# UNITED STATES PATENT AND TRADEMARK OFFICE

APPLICATION NO.	FILING DATE	FIRST NAMED INVENTOR	ATTORNEY DOCKET NO.	CONFIRMATION NO.
10/748,047	12/30/2003	Roger Adrien Boutin	5709-168	6747

<b>Office Action Summary</b>	<b>Application No.</b> 10/748,047	<b>Applicant(s)</b> BOUTIN, ROGER ADRIEN	
	<b>Examiner</b> Jerry Redman	<b>Art Unit</b> 3634

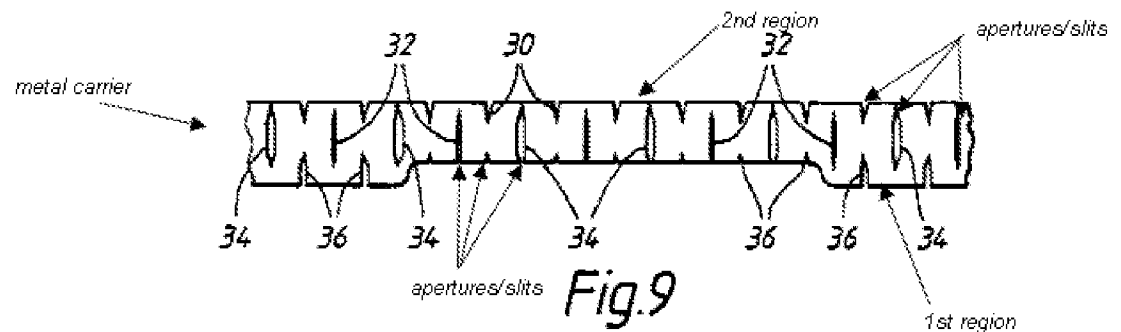
Claims 1-21 are rejected under 35 U.S.C. 102(b) as being clearly anticipated by Bright et al. (5,752,345). As shown in Figure 9, Bright et al. (5,752,345) disclose a weather strip (12) in combination with a motor vehicle (see figure 1) comprising a steel metal carrier (22) having a U-shaped cross-section (sealing flanges each side of the weather strip) having a first region having a first flexibility along a longitudinal length (see figure below) and a second region having a second flexibility along the longitudinal length (see figure below), and an elastomeric material (14) disposed about the metal carrier (22) and including a tubular/hollow sealing feature (16) extending from the weather strip (12). Bright et al. (5,752,345) further disclose the first region having a plurality of apertures disposed generally centrally along the carrier (22). Bright et al.

(5,752,345) still further disclose the second region having a plurality of slits (see figure below). Bright et al. (7,752,345) still further disclose the first region and second region to have distinct flexibilities (column 4, lines 50-60).
